**TOWN OF NEWBURGH
PLANNING BOARD
TECHNICAL REVIEW COMMENTS**

PROJECT NAME: DRIVANOS- 2 LOT SUBDIVISION/LOT LINE CHANGE
PROJECT NO.: 2024-09
PROJECT LOCATION: SECTION 2, BLOCK 1, LOT 14 & 15
REVIEW DATE: 27 SEPTEMBER 2024
MEETING DATE: 3 OCTOBER 2024
PROJECT REPRESENTATIVE: ZEN CONSULTANTS

SITE PLAN

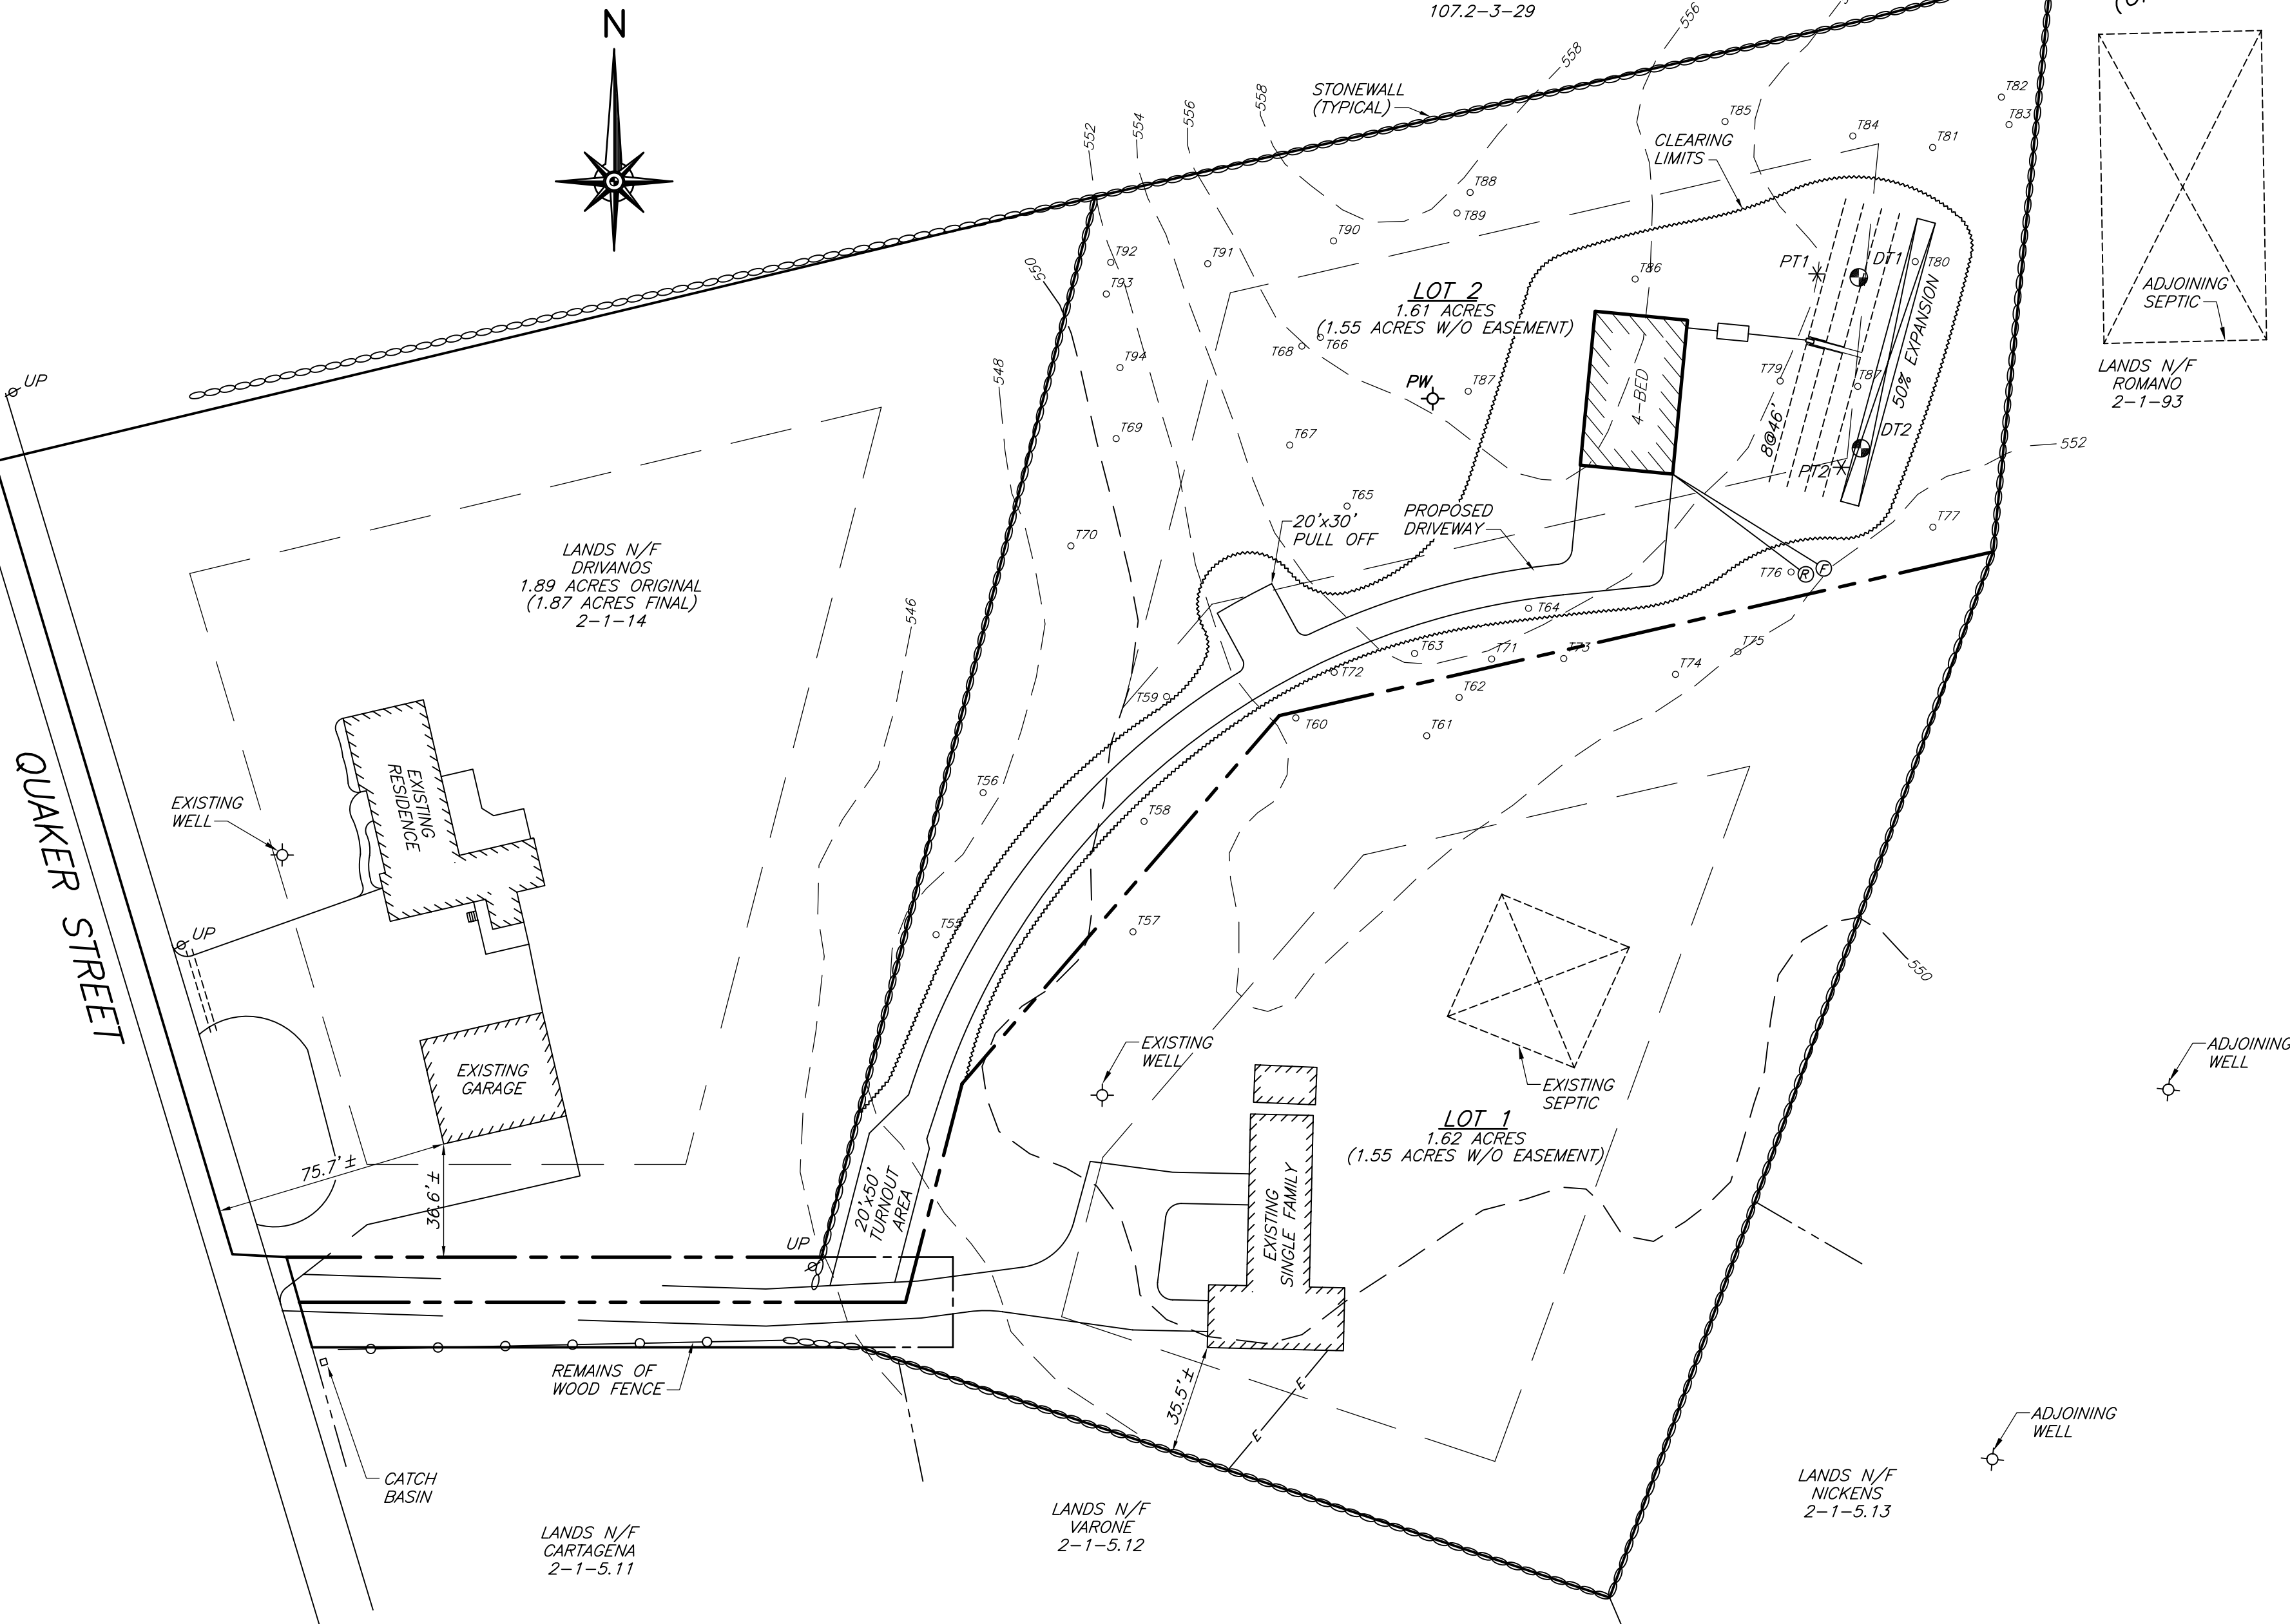
4. Information pertaining to the Tree Survey has been added to the plans. Significant and Specimen trees have been identified on the proposed new lot.
5. Tree removal is below the threshold where mitigation would be required. the trees to be removed in a limit of disturbance have been identified. The percent removal would be less, as trees on existing Lot #1 which are to remain, would lower the threshold identified if included in the existing tree information.

7. Clearing limits have been depicted on the plans. The area of the limit of disturbance should be identified.
8. Code Enforcement Office's comments on the turn-out areas and pull-offs proposed should be received.

9. The project requires a Public Hearing.
10. A Long Form EAF has been previously prepared for the project. The EAF identifies .3 acres of disturbance. The amount of disturbance should be clarified. Review of the EAF identifies that the project site is in a Red Maple-Hardwood swamp natural community. Project has a very small limit
